**RE: Greenland Beach Lot 29 and P/O Lot 28**  
**408 Greenland Beach Road, Baltimore, MD 21226**  
**Tax Map 11 Block 15 Parcel 29**  
**Tax Account # 3395-0121-5500**

On behalf of the property owner, I am submitting a variance application for the above-referenced project. The property owner proposes demolishing an existing garage to allow for the construction of a 22'x28' detached garage with a second-floor Accessory Dwelling Unit. The garage/accessory dwelling unit will have an average roof height that is higher than the principal structure. The existing dwelling is a single-story home that was built in 1900. The house has an average roof height of 11' 10". The proposed garage/ accessory dwelling unit will have an average roof height of 20' 3". The structure has an overall footprint of 22' x 28' and is setback, at its closest point, 7' from the eastern, side lot line and 7' from the northern rear lot line and 11' from the western side lot line.

### CONFIRMATION OF PRE-FILE (2025-0106-P)

#### **PLANS**

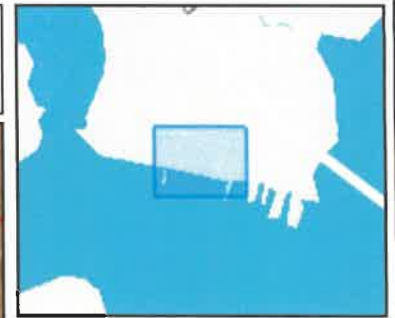
Zoning Administration Section: It appears that the applicant can construct a one story detached ADU without the variance and still provide the desired home for the family member. The proposed structure seems excessive and is not likely to be supported by this Office. The site plan labels the proposed structure height as "peak height" and the existing dwelling height as "height". Please make sure the labels for the height of the structures are consistent and provides the height measurement required for the building permit.

Response: We feel this proposed garage/adu is modest in size when we take into consideration that we still need the 2-off-street parking space that the existing garage provides. This lot is only 40' wide at the right of way. This limits the area to park cars. The existing driveway needs to access the existing house so no parking can happen along the side. This is the need to build the garage with the adu on top. The average roof height has been provided on the site plan.

The peak height is called out for both structures.

FRONT ELEVATION  
SCALE 1/4" = 1' FOOT

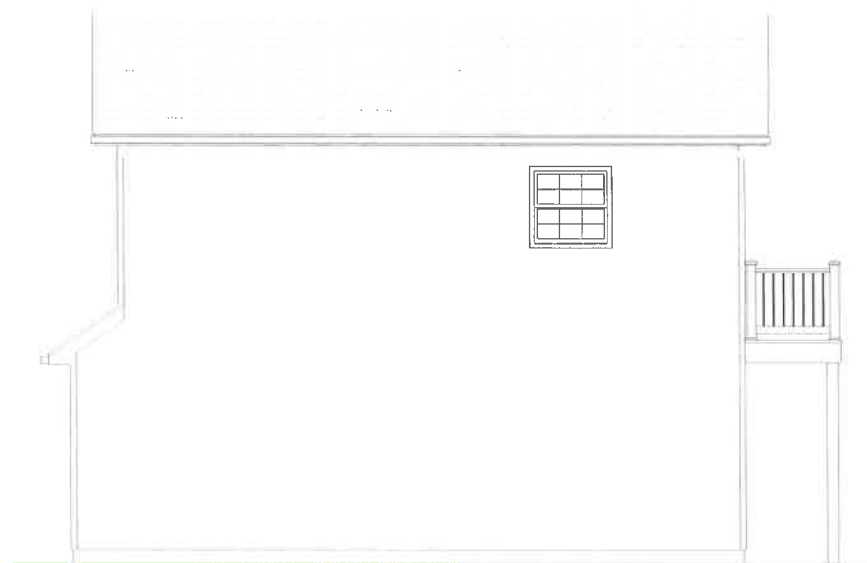
The Department of Inspections and Permits (Engineering Division): Show and label existing and/or proposed stormwater management devices. Show the access to the exterior steps. Show and label the existing water meter and sewer clean out locations.

Response: There are no existing stormwater management devices to show. We will be required to address stormwater management with the building permit. Stormwater management will be addressed via planting for the increase of lot coverage. The sewer and water cleanout have been added to the administrative site plan. Construction plans have been submitted as part of this application. These plans show access to the outside steps.

NO STEPS ALONG  
SIDE OF GARAGE/  
ADU

## STEPS FROM DECK TO ACCESS ADU
